# Access Compliance Report

## Public Rights-of-Way

### (Curb Ramps)

Intersection ID: N/A	Main Street: PHILLIPS_PLACE_CT	Cross Street: CAMERON_VALLEY_PY	Location: SE
ADA ID: 17D4CA338660	Ramp Type: Perp	Initial Pass/Fail: Fail	Overall Compliance: No
Severity Score: 1.25			
Codes/Mitigation Info/Possible Solution		Field Measurements/Component Compliance

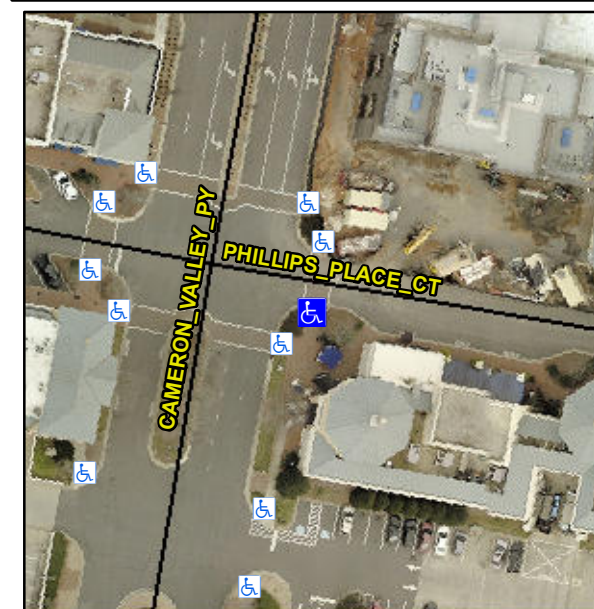
**Remove & Replace Entire Ramp.**

**Not Found, R304.5.3**

Compliance	Description	Data	Compliance	Description	Data
N/A	Ramp Length (in)	31.0	Yes	Ramp Slope (%)	8.0
Yes	Ramp Width (in)	150.0	No	Ramp XSlope (%)	4.7
N/A	Flare Type LT	N/A	N/A	Flare Type RT	N/A
N/A	Flare Slope LT (%)	N/A	N/A	Flare Slope RT (%)	N/A
N/A	Flare Traversable LT?	N/A	N/A	Flare Traversable RT?	N/A
N/A	Landing Length (in)	N/A	N/A	DWS Provided?	N/A
N/A	Landing Width (in)	N/A	N/A	DWS Contrast?	N/A
N/A	Landing Slope (%)	N/A	N/A	DWS Length (in)	N/A
N/A	Landing X Slope (%)	N/A	N/A	DWS Full Width?	N/A
N/A	Landing Curb? (Y/N)	N/A	N/A	DWS Offset (in)	N/A
N/A	Shared Landing?	N/A			
N/A	Gutter Ponding?	N/A	N/A	Gutter Slope (%)	N/A
N/A	Gutter Lip Ht (in)	0.5	N/A	Gutter X Slope (%)	N/A
N/A	Painted X Walk1?	Yes	N/A	Painted X Walk2?	N/A
	X Walk 1 Direction	To NE		X Walk 2 Direction	N/A
N/A	X Walk 1 Width (in)	146.0	N/A	X Walk 2 Width (in)	N/A
	X Walk 1 Slope (%)	0.8		X Walk 2 Slope (%)	N/A
	X Walk 1 X Slope (%)	3.6		X Walk 2 X Slope (%)	N/A
